Reviewer #1.

This is a review for "Parameterizing spectral surface reflectance relationships for the Dark Target aerosol algorithm applied to a geostationary imager" from Kim et al. This manuscript extends the well known Dark Target (DT) aerosol retrieval algorithm to the geostationary (GEO) imager ABI on GOES-16 by modifying the so-called Surface Reflectance Parameterization (SRP). This key processing step of the DT algorithm allows it to constrain the spectral variation of surface reflectance as a previous step to the estimation of aerosol properties over dark surfaces. The topic of the manuscript is of high interest for the atmospheric community and very appropriate to AMT because GEO imagers such as ABI are becoming increasingly compelling for aerosol remote sensing thanks to their high revisit time and their increasingly advanced sensing performances. The experiments described in the manuscript are relevant and most of results are convincing. However, and although it reads quite well most of the time, the manuscript would benefit of a careful revision, especially in some sections that are a bit too long (with redundant information) and some others that despite being key are a

Figure A1 Comparison of  $NDVI_{GEO\_SWIR}$  and  $NDVI_{LEO\_SWIR}$  derived from MODIS (Aqua) TOA reflectance at six locations from Jan 2017 to June 2020. Color indicates the location. The names and numbers shown in the legend indicate the dominant land types and their occupancy at each location.

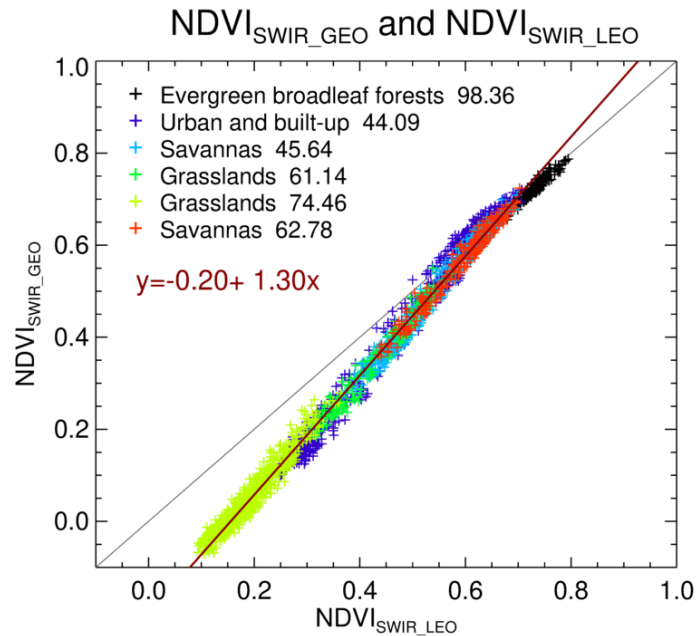
- Line 225. Using 0.86 to replace 1.24 is a good choose. I prefer to a similar indicator named ‘AFRI’ (10.1016/s0034-4257(01)00190-0), and it shows a good consistency (slope close to 1) with MODIS NDVISWIR and shows relatively good atmospheric resistance (10.1109/TGRS.2020.3021021). The discussion of the NDVI index selecting should be extended here because it is one of the key steps of the DT method, and this problem also usually appears when applying the DT method to other sensors.

Thanks for this comment.  $NDVI_{GEO\_SWIR}$  used is based on the  $NDVI_{MIR}$  defined in Karnieli et al. (2001) and Miura et al., 1998. To clarify the background of  $NDVI_{GEO\_SWIR}$ , we added the references [A. Karnieli et al (2001) ; Jin et al., 2021] on lines 224-225.

We also conducted a study to check a consistency between  $NDVI_{LEO\_SWIR}$  and  $NDVI_{GEO\_SWIR}$ . The study is based on the MODIS TOA reflectance, which has both 0.86  $\mu m$  and 1.24  $\mu m$  channel. We derived the indices for 3.5 years (01.2017-06.2020) at six selected AERONET sites (Table A1) covering different land cover types.

The Fig. A1 shows  $NDVI_{LEO\_SWIR}$  and  $NDVI_{GEO\_SWIR}$  has a good consistency with linear regression.  $NDVI_{GEO\_SWIR}$  matches  $NDVI_{LEO\_SWIR}$  in dense vegetation where both  $NDVI_{SWIR}$ s are high but falls to lower values at the low end in scenes with less vegetation coverage. Accordingly, in the SRP, the  $NDVI_{GEO\_SWIR}$  increases the number of cases assigned into the low  $NDVI_{SWIR}$  category ( $NDVI_{SWIR} < 0.25$ ) from 25.5% to 41.5%. This means that without modifying the threshold on  $NDVI_{GEO\_SWIR}$  the SRP will be encountering pixels never used before by the DT algorithm. The red surface reflectance will be parameterized differently in areas with less vegetation, which may lead to differences between DT GEO and DT LEO retrievals. It requires a new NDVI threshold or SRP improvement for the DT GEO retrieval.

The NDVI comparison has been added into Appendix A. and discussed in lines 225-232.

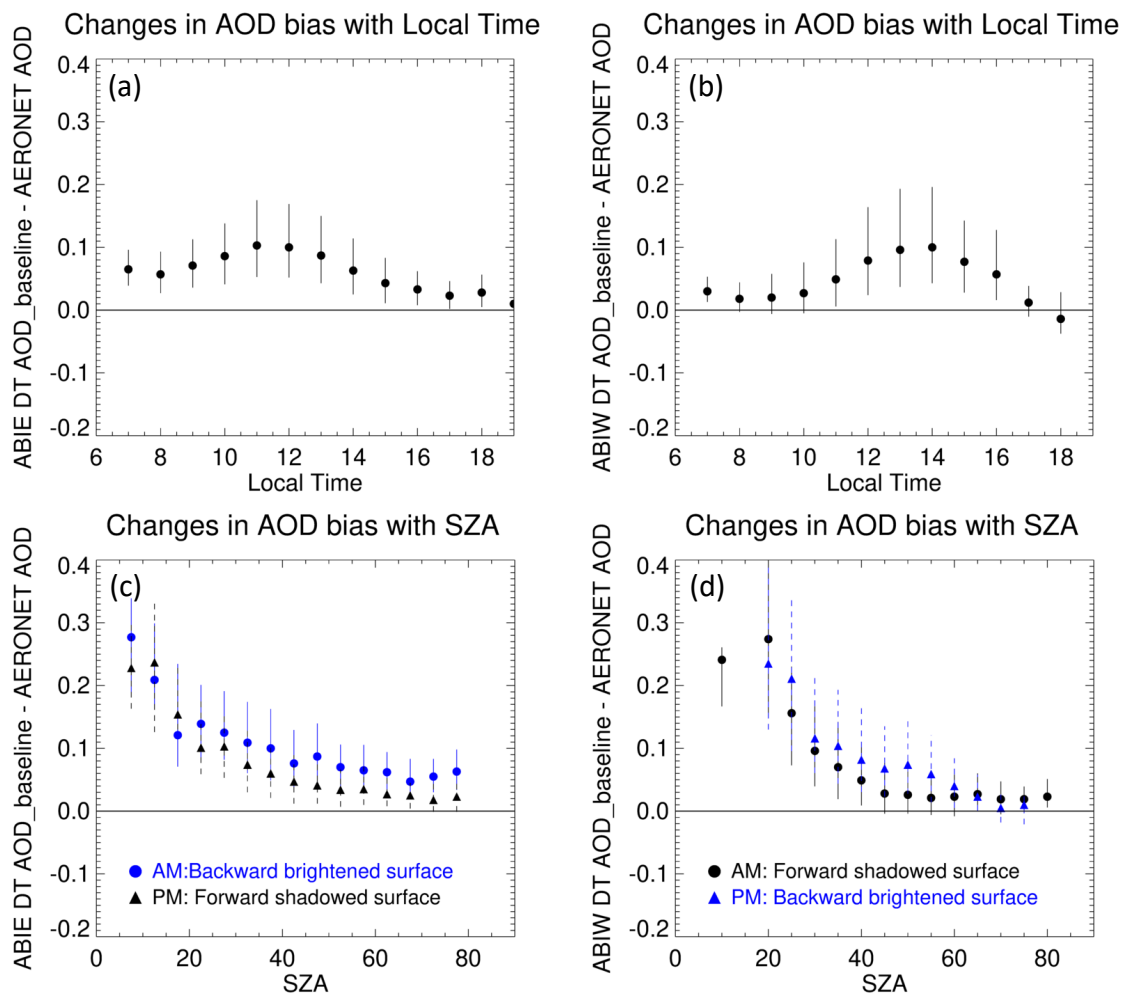
- Line 305-314: Yes, the discussion here is meaningful. This means we need to pay more attention to the details of the observational geometry than just the scattering angle. In addition, considering the particularity of the DT method, this probably also be only related to the instrument itself. For example, the AOD also has nonnegligible difference between MODIS/Terra and MODIS/Aqua. And in your study, the ABIE and ABIW also show difference in distributions of AOD bias as Figure 3. When applying the DT method to the AHI/Himawari (10.5194/amt-12-6557-2019), the dependence of AOD bias with time is not emphasized. So, the differences between different hardware are also large, and comparing with the time dependence, the overestimation of AOD (positive bias) may be more noticeable. In this case, it is necessary to re-formulate the SRP.

Thank you for bringing up this concern. Following the reviewer’s feedback, we have revised section 3.2. Sensor calibration status can influence retrieval performance. However, if sensor specifications are the same, we do not anticipate significant biases due to hardware differences compared to the uncertainty in surface reflectance. To enhance our understanding of the difference in the AOD bias between ABIE and ABIW, we revised Fig. 4 to include the bias dependency on SZA (description on lines 320-328).

Figure 4(c,d) illustrates that the DT bias overall increases as SZA decreases, but with differences depending on the scattering direction between the Sun and the satellite. ABIE AOD exhibits a higher bias in the morning (Fig. 3c), as shown by the time dependence showcasing a distribution skewed towards the morning (Fig. 4a). In contrast, ABIW AOD shows a greater bias in the afternoon than the morning (Fig. 4d), aligning with the afternoon-skewed distribution (Fig. 4b). This time dependence is consistent in that the bias is relatively large when the direction in which the satellite faces the Earth's surface matches the direction in which sunlight arrives. In other words, the AOD bias is also influenced by the RAA, showing a reduced bias during low RAA conditions when the surface appears relatively dark due to shadows cast by the canopy. This means we need to pay more attention to the details of the observational geometry than just the scattering angle.

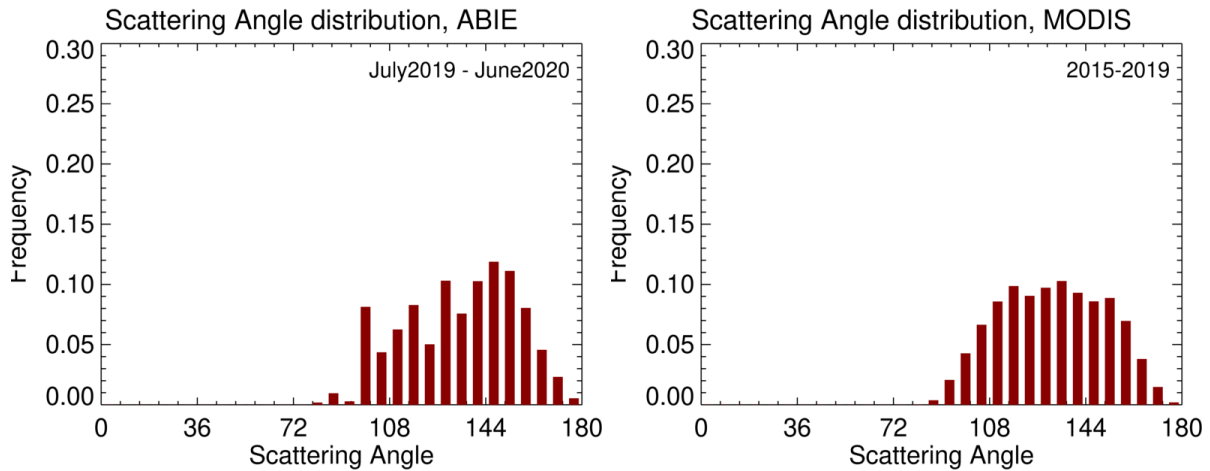
- Figure 9: I find the points in ABIE are more discrete, especially between SWIR and Red bands. This is possibly the impact from large SZA.

Thank you for bringing this to our attention. The discrete distribution of bins is influenced by the scattering angle distribution. For reference, here we showed a comparison of the frequency distribution of scattering angles obtained from the entire collocation dataset for both ABIE (left) and MODIS (right). In contrast to MODIS, which exhibits a uniform distribution between 100° and 160°, ABI angles are primarily concentrated in the range of 130° to 160°. As a result, the points analyzed in ABIE are relatively dense within the 130°-to-160° range, but sparse elsewhere.

Frequency distribution of Scattering angle calculated from the AC-ref dataset for each ABIE and MODIS. The ABIE dataset covers the one year period from July 2019 to June 2020, and the MODIS dataset is for 5 year between 2015 to 2019.

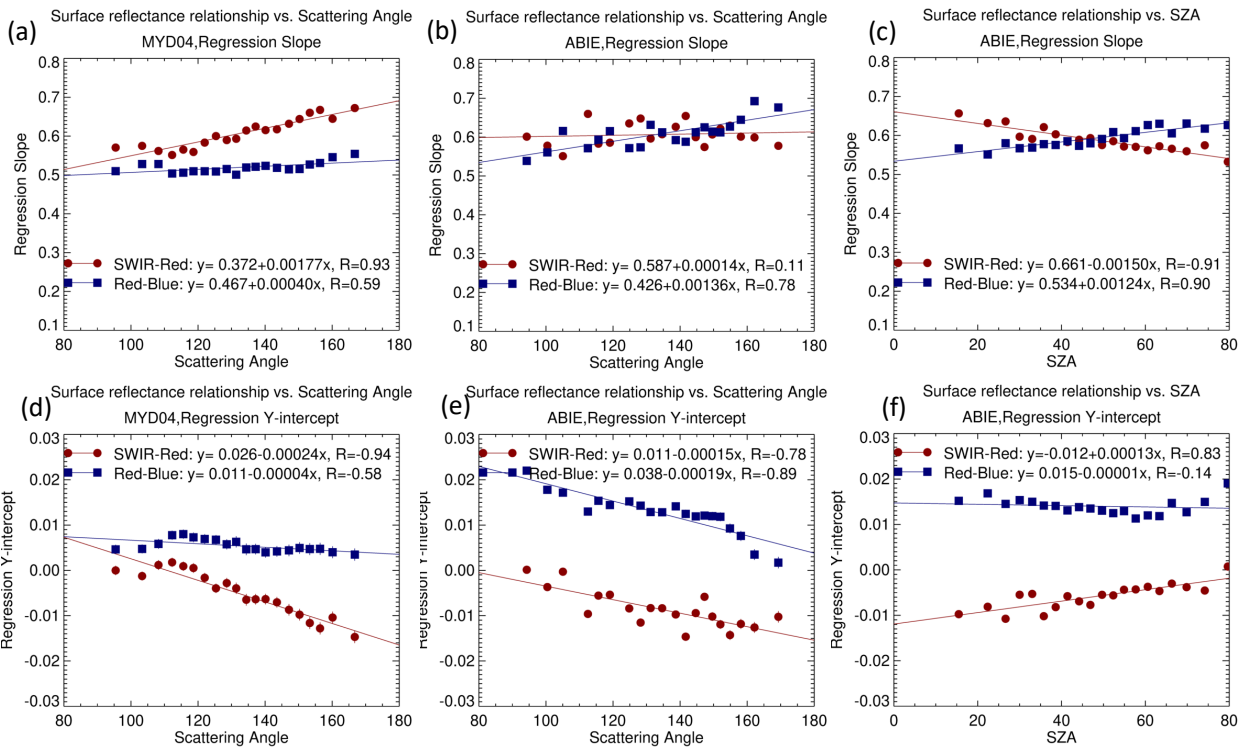
- I wonder whether the relationship between Blue, Red and SWIR bands changes with SZA (similar to the representation in Figure 8-9). This is meaningful to study the time dependence of AOD bias.

Thanks for this comment. We have added the changes with SZA as follows (Fig. 10, lines 442-444);

*“While the Red vs. SWIR regression shows weak dependence on the scattering angle, the regression changes linearly with SZA in Fig. 10(c) and Fig. 10(f). As SZA increases, the slope increases, and the interception decreases. The linear dependence is also evident in the blue-red relationship, although the points are slightly deviating from the linearity when SZA is high (>70°).”*

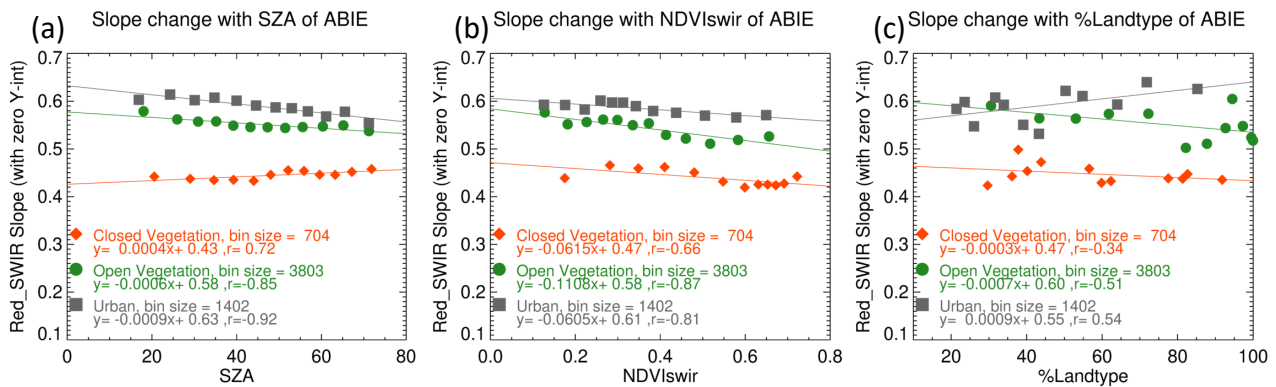
- Figure 12: This figure is interesting and shows the difference of SRP dependence between OV and CV. But what worries me is that the divergence between the data points is so large that it seems to outpace the trend itself. In addition, the SRP dependence does not show a clear change with percent of OV or CV. This is possibly owing to the features of OV and CV, which are not significant enough (IGBP is a climatological classification product). By contrast, the urban percent is an opposite.

We agree with the reviewer's comment. The Fig. 13 was modified to confirm the linearity of the regression change more clearly. Lines 515-526 of the manuscript has been modified as well.

*"In Fig. 13 we look for dependencies of the regression by plotting the slope against SZA,  $NDVI_{SWIR}$  and the different land cover type percentages. In this figure, we simplified the regression to force the y-intercept to 0 and display the derived slope to make it easier to see the linearity of the regression change with the parameters. For vegetative surface, slopes from the red-SWIR regression range between 0.4 to 0.6, and slope variability is well captured by parameterization*

using  $NDVI_{SWIR}$ . The slope of the CV group shows a weak dependence on the parameters, with a slight decrease observed with increasing  $NDVI_{SWIR}$  (Fig. 13b, red) and %CV (Fig. 13c, red). When the surface becomes even darker, where  $NDVI_{SWIR}$  is greater than  $\sim 0.6$ , the regression tends to lose its sensitivity to the  $NDVI_{SWIR}$ . The slopes of the OV group behave similarly, but the dependence on  $NDVI_{SWIR}$  and %OV is stronger compared to the CV group. An increase in vegetation percentage is expected correspond to a darkening of visible surface reflectance, and thereby decreases the Red vs. SWIR slope. The urban slope also decreases as  $NDVI_{SWIR}$  increases, but as % urban increases, it increases due to the greater contribution of high reflectance from human-made structure. The slope is high when SZA is low for groups of OV and urban, but in the CV group, a weak positive change is shown.”

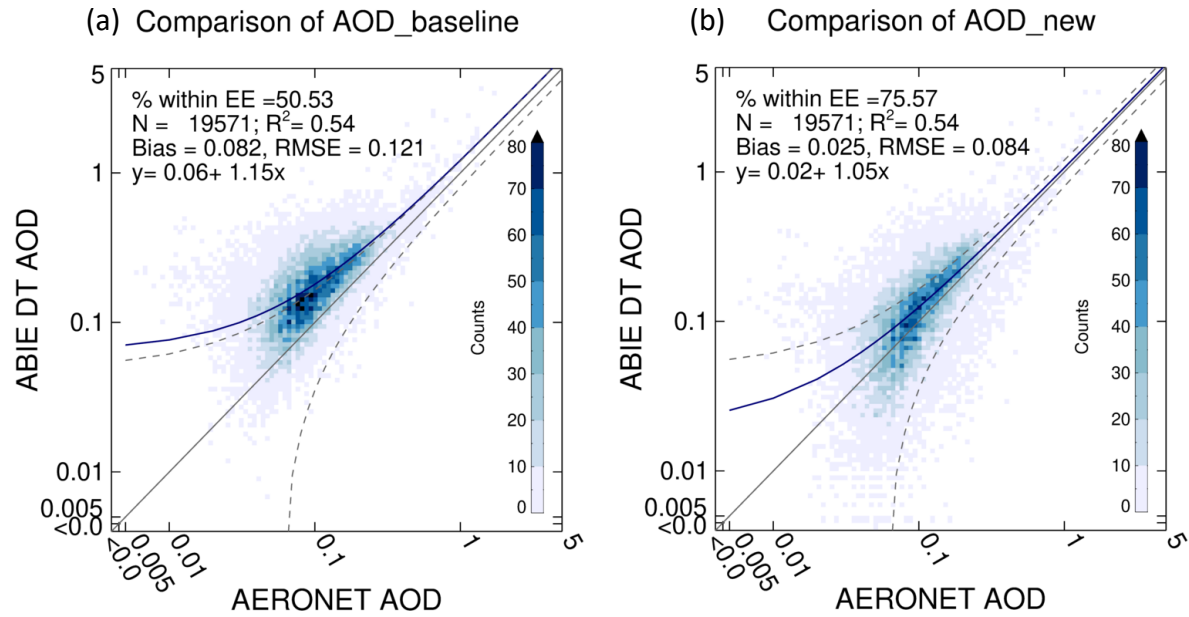
- Although figures 15-17 are useful to describe the results of this new method. However, there is still a lack of a total validation scatter plot to represent the overall retrieval results, error distributions, and before and after improvements, as many other studies have done.

We agree with this comment and have added DT AOD validations (Fig. 19 and description on lines 618-625).

*“The scatter plots in Fig. 19 compares the DT AODs with AERONET AOD. By applying the new SRP, the %EE has been improved from 50.53% to 75.57%, and the regression slope became closer to 1. Figure 20 shows the same plots as seen in Figure 17 but for three specific AERONET site, GSFC, NEON Harvard, and PNNL, which are dominated by Urban (44.09%), mixed forests (47.57%), and Croplands (86.87%), respectively. The AERONET sites are observed from ABIE with fixed VZA of 45.42°, 49.38°, and 68.99°, respectively. The new SRP reduces the AOD bias at the three AEROENT site but has less impact on the mitigation of the time-dependence at PNNL. The AOD retrieved at PNNL may have greater uncertainty in that the site is located at the high VZA near the boundary of ABIE's observing disk, and the cropland surface contributed to the bright reflectance. ”*

Figure 1. AERONET map with observations available for AC-ref calculation (AOD at 550 nm < 0.1, AE > 1.0) between July 2019 and June 2020. The color represents number of valid observation which meet the criteria and applied to the AC\_ref calculation.

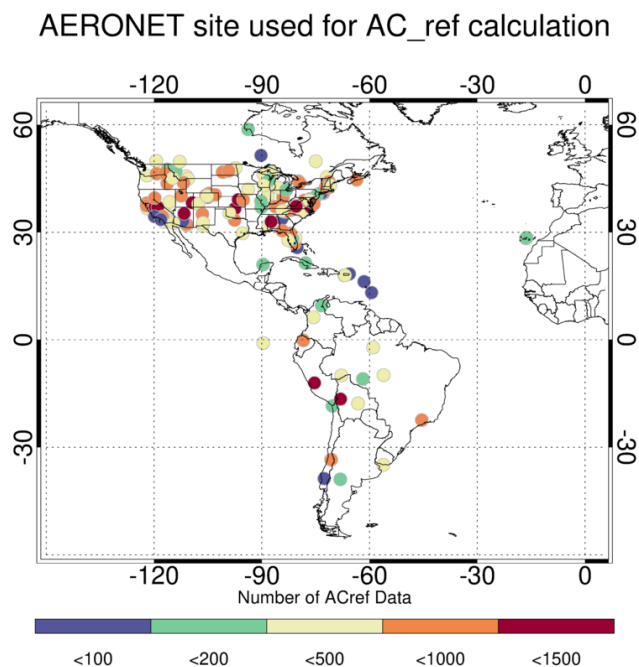
-L252: "The 193 AERONET site" -> sites. Where does the 193 figure come from? Is it the total of available sites? Or some selected sites? Showing a map of AERONET sites would be of interest here and would definitely help to better analyze Fig. 17 for which some stations seem to be missing.

Kim et al. (2021) [<https://doi.org/10.1016/j.atmosenv.2020.117994>] conducted a study on the global distribution of 'background AOD [BAOD]'. The study defines BAOD as the average of the lowest 5th percentile of AOD measured at each AERONET site. The result indicates that the maximum BAOD was 0.18 in South Asia, while in the remaining regions, BAOD remained below 0.10 throughout the year. Which means, in the most of AERONET sites, AOD lower than 0.1 accounts for at least 5% of total observations. Although the data periods are different, it was assumed that there would be sufficient observations to meet the criteria at most AERONET site.

The Fig.1 shows the locations in AERONET used for AC-ref calculations, with the colors indicating the number of datasets used. The map illustrates sufficient data pools within the ABIE FOV at each AERONET site.

The sentence has been modified in lines 374-376 to show the proportion of the data set for which 1640 nm observations are available. We found that 84% of the observations contained a valid 1640 nm AOD. The map displaying AERONET sites used for the AC-ref calculation was shown in Fig. 1 in the revised manuscript.

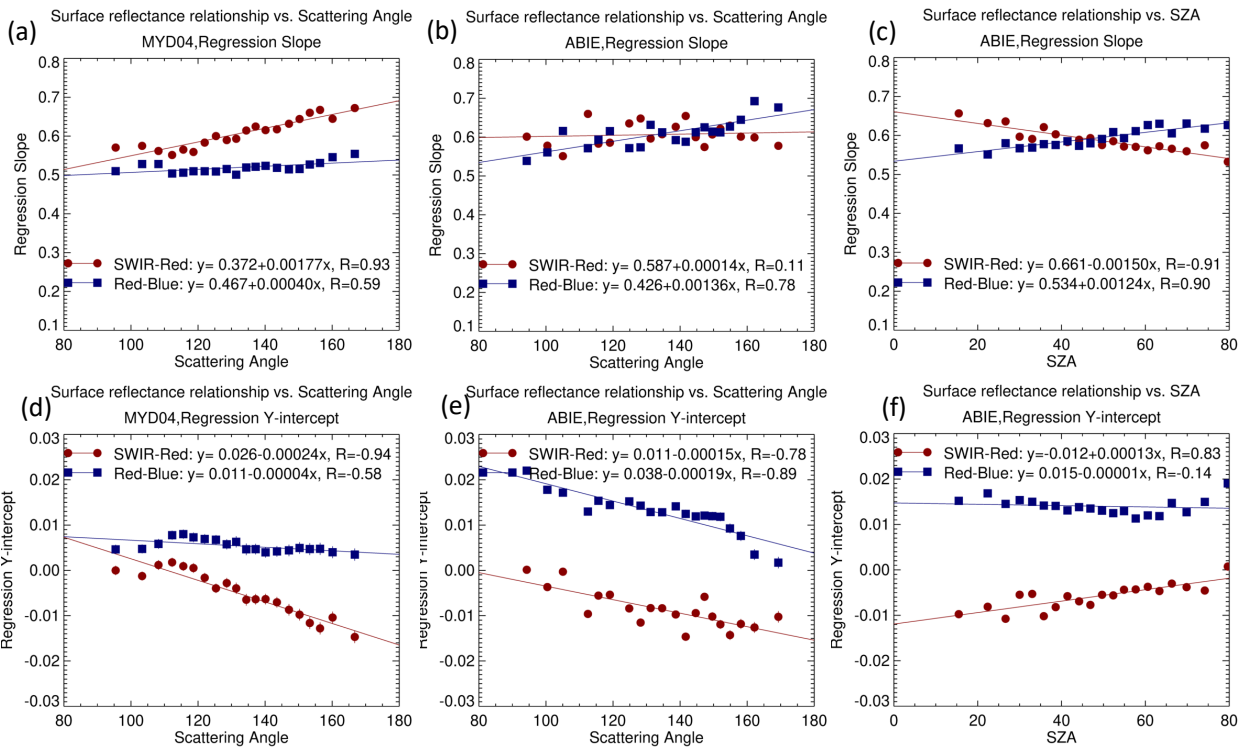
-P14, Fig.9: Would plots against SZA be clearer than against xi?

Thanks for this comment. We have added the changes with SZA (shown below) to Fig. 10, and described them in lines 442-444.

*“While the Red vs. SWIR regression shows weak dependence on the scattering angle, the regression changes linearly with SZA in Fig. 10(c) and Fig. 10(f). As SZA increases, the slope increases, and the interception decreases. The linear dependence is also evident in the blue-red relationship, although the points are slightly deviating from the linearity when SZA is high (>70°).”*

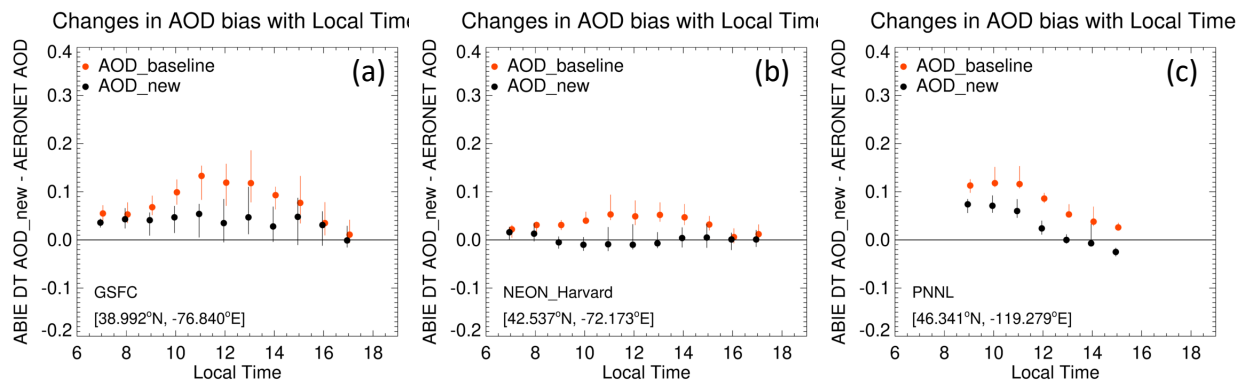
-Fig. 16 is convincing but I would like to see the same plots for a few sites with different information content on aerosols (cad. different surface reflectance and location/geometry). For example, what happens over the GSFC site with respect to Fig. 6b? A site in a more arid area (Midwest?) would be great too. Also, please detail the period of time that was considered to generate this plot.

The following figures showing the same plots for Fig. 17 are obtained from three AERONET site, GSFC, NEON Harvard, and PNNL, where are dominated by Urban (44.09%), mixed forests (47.57%), and Croplands (86.87%), respectively. The AERONET sites are observed from ABIE with fixed VZA of 45.42°, 49.38°, and 68.99°, respectively. The new SRP reduces the AOD bias at the three AEROENT site but has less impact on the mitigation of the time-dependence at PNNL. The AOD retrieved at PNNL may have greater uncertainty in that the site is located at the high VZA near the boundary of ABIE’s observing disk, and the cropland surface contributed to the bright reflectance.

*Difference between the new and baseline DT AOD corresponding to the changes in surface reflectance at Red. The DT AODs are compared at three AERONET site, GSFC, NEON\_Harvard, and PNNL between August and September in 2019. The color indicates scattering angle.*

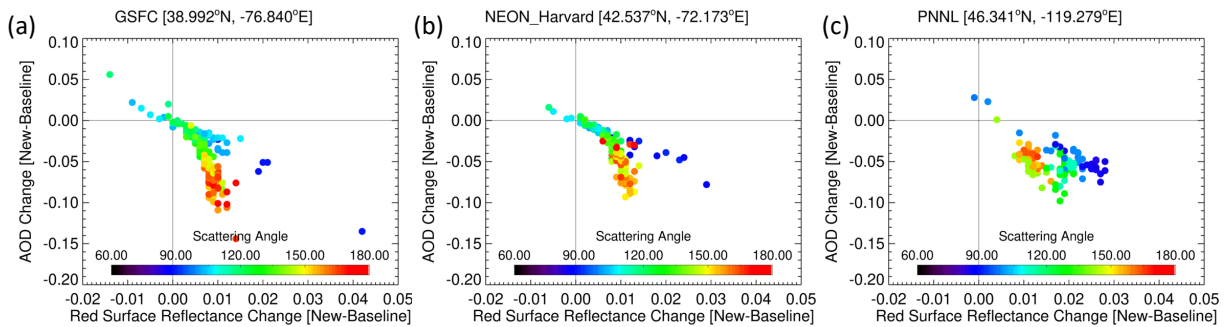
-Generally on the results, it would be interesting to investigate the link between surface reflectance change and AOD change (between baseline DT and new DT), and all this according to

scattering angle. I would not be surprised to see that AOD improves more for angles associated to a lower information content despite experiencing similar reflectance changes.

The following figures shows the link between surface reflectance change (at red) and AOD change [new – baseline] according to the scattering angle. In most case, the surface reflectance is increased by applying the new SRP, and thereby the AOD is decreased. The changes in AOD and surface reflectance are clearly distinguishable depending on the scattering angle. The AOD change is significant where the scattering angle is higher than  $\sim 150^\circ$  despite the surface reflectance change is small.

*This figure has not added into the revised manuscript because the decreasing AOD and its angle dependence were already seen in the previously shown figures.*
